INITIAL FIRE SAFETY INSPECTION REPORT

JL Fashions Limited (Relocated)

Factory ID: 24200

Date: 12 August 2021

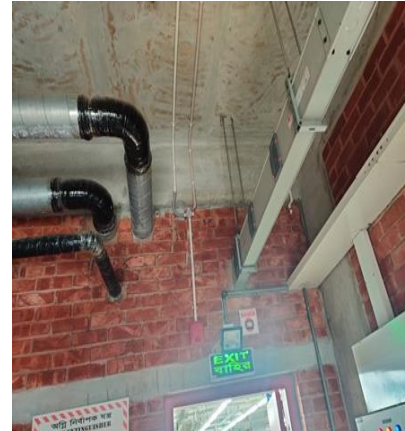
SI No.	Category	Findings	Required Action	Remediation Time Frame
F-1	Fire Rated Construction	<p>Storage discharges directly into the exit stair discharge.</p> <p>Location: Main building 1st floor</p>	<p>Openings from exit enclosure to storage room, generator and transformer spaces shall be provided with a vestibule with fire rated construction and openings.</p> <p>Provide a 1.5 hr. fire rated door on the exit stair side and a 1-hr. fire rated door on the Store, generator, sub-station room side. Ensure that the fire rating of the vestibule construction matches that of the exit stair enclosure.</p>	Within 3 months
